ADDENDUM

Client: Department of Natural Resources
Project: Pokagon State Park Toboggan Run Piping Upgrades
Client Project No.: ENG2003780646
Applied Project No.: 19-110
Addendum No.: 2
Date: 11/24/2020

C HEAT TRACE CONDUIT CONNECTION DETAIL
SCALE: NONE

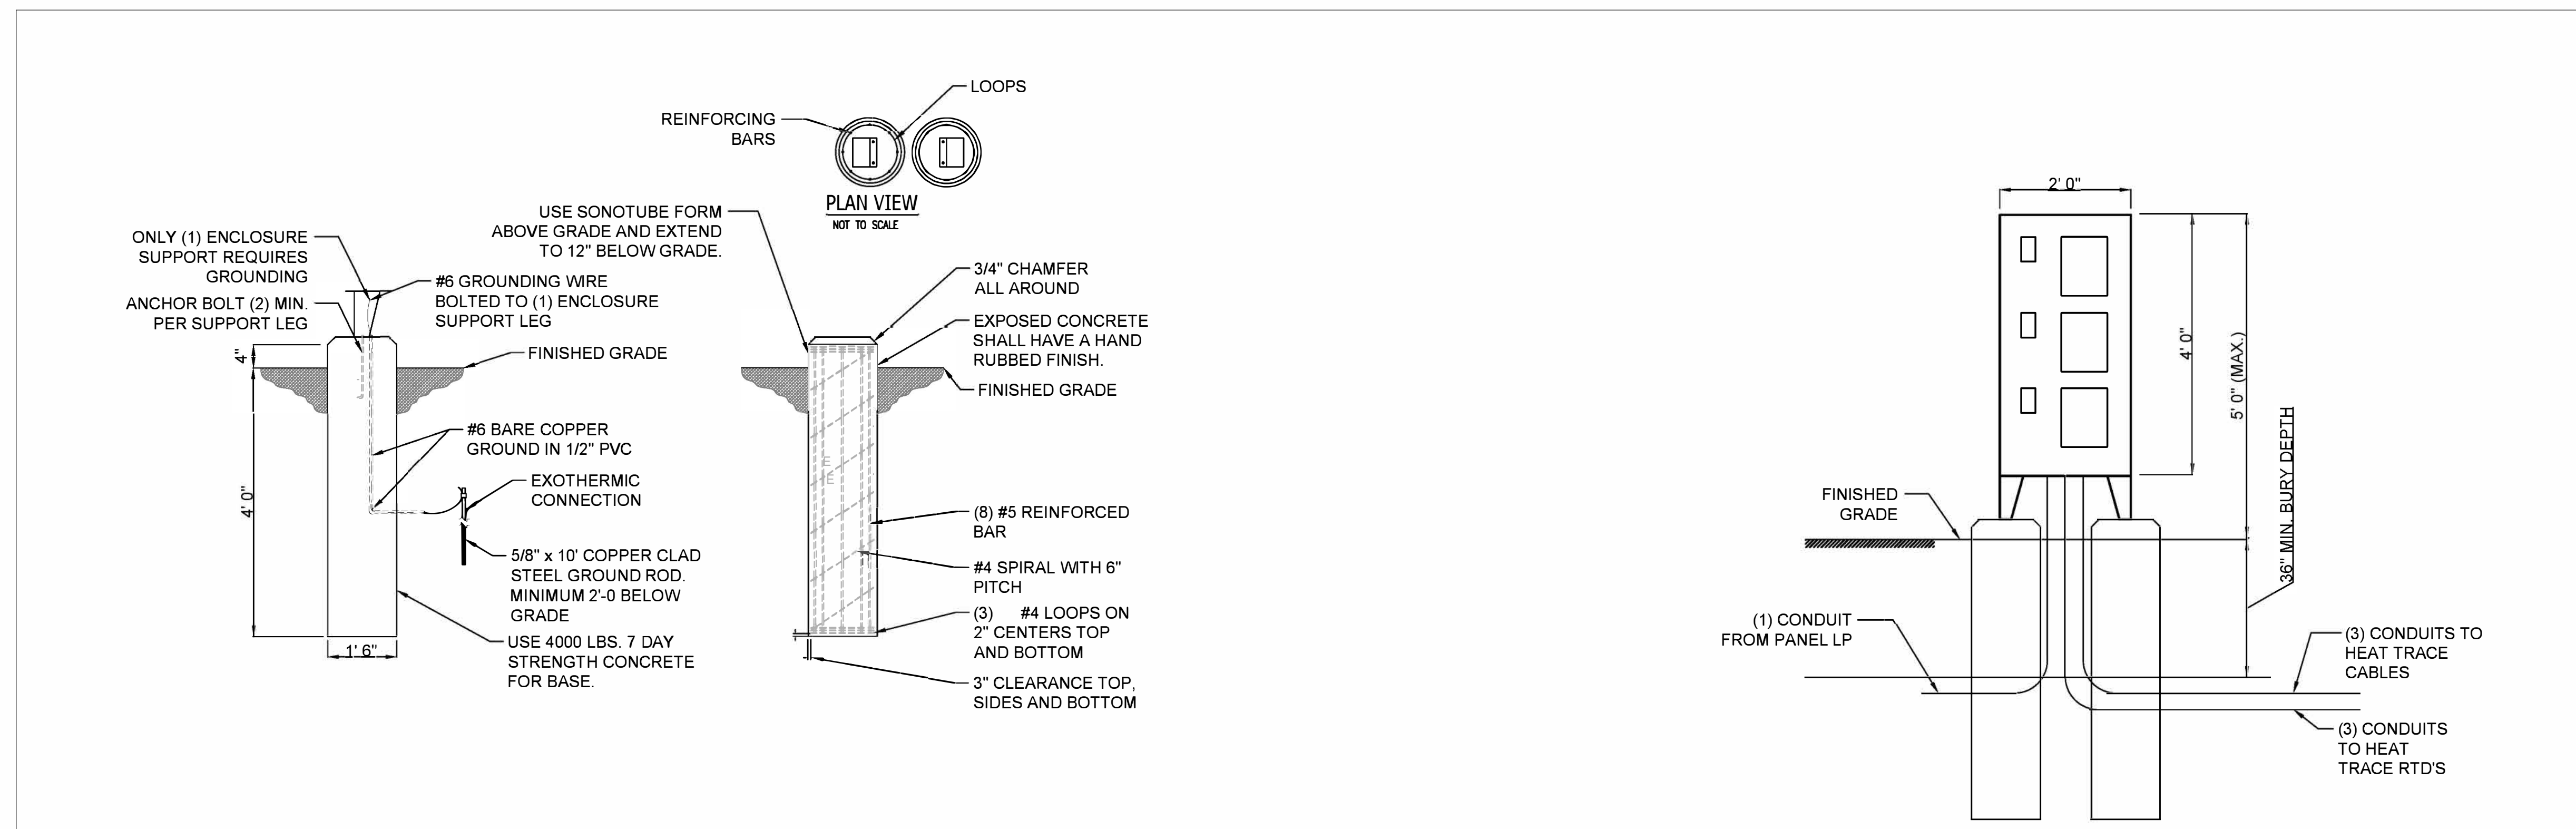
- b. Can someone provide details surrounding how the electrical tracing would be routed from the actual piping shrouds to the vaults?
 - a. RESPONSE: Heat tracing conduit route is clarified on details added to sheet E501 this Addendum #2.

- c. Should the electrical tracing utilize new conduits from the shroud to the vault, is there an existing pipe duct we can use, can they be laid bare?

- d. Is there an existing pipe chase that the conduits can be installed through under the tracks?
 - a. RESPONSE: An empty space exists where cooling pipe manifolds feed copper tubing within the track. This open space exists under the two inner track shrouds. The two outer track shrouds may not have an existing opening from below. Heat tracing conduit route is clarified on details added to sheet E501 this Addendum #2.

- e. Is there a detail on how the actual tracing would penetrate through the existing concrete slab and into the piping shrouds?
 - a. RESPONSE: Heat tracing conduit route is clarified on details added to sheet E501 this Addendum #2.

- f. It appears that there may not be ample room in the vaults for the heat tracing terminal boxes, can they be mounted above grade and external from the vault?

- h. Could the conduits originating at the Heat trace Control Panel be arranged, based upon the answers from the above questions, all on one side of the track so that boring or undermining the existing track can be avoided? This would only apply if the heat tracing terminal boxes can be mounted remotely from the vaults.

- i. Vault #24 is in a precarious position from the track system, is there a design recommendation as to how to install UG conduits to the vault and electrical tracing from the piping shroud to the terminal box or into the vault?
 - a. RESPONSE: Heat tracing conduit route is clarified on details added to sheet E501 this Addendum #2.

- a. RESPONSE: A pipe duct for heat trace routing does not currently exist. Heat tracing conduit route is clarified on details added to sheet E501 this Addendum #2.

- a. RESPONSE: A tee on a single circuit will be used in the heat trace power connector where heat tracing runs in two directions. Heat tracing conduit route is clarified on details added to sheet E501 this Addendum #2.

- a. RESPONSE: To reach each section of track the circuit must pass under the track. Heat tracing conduit route is clarified on details added to sheet E501 this Addendum #2.
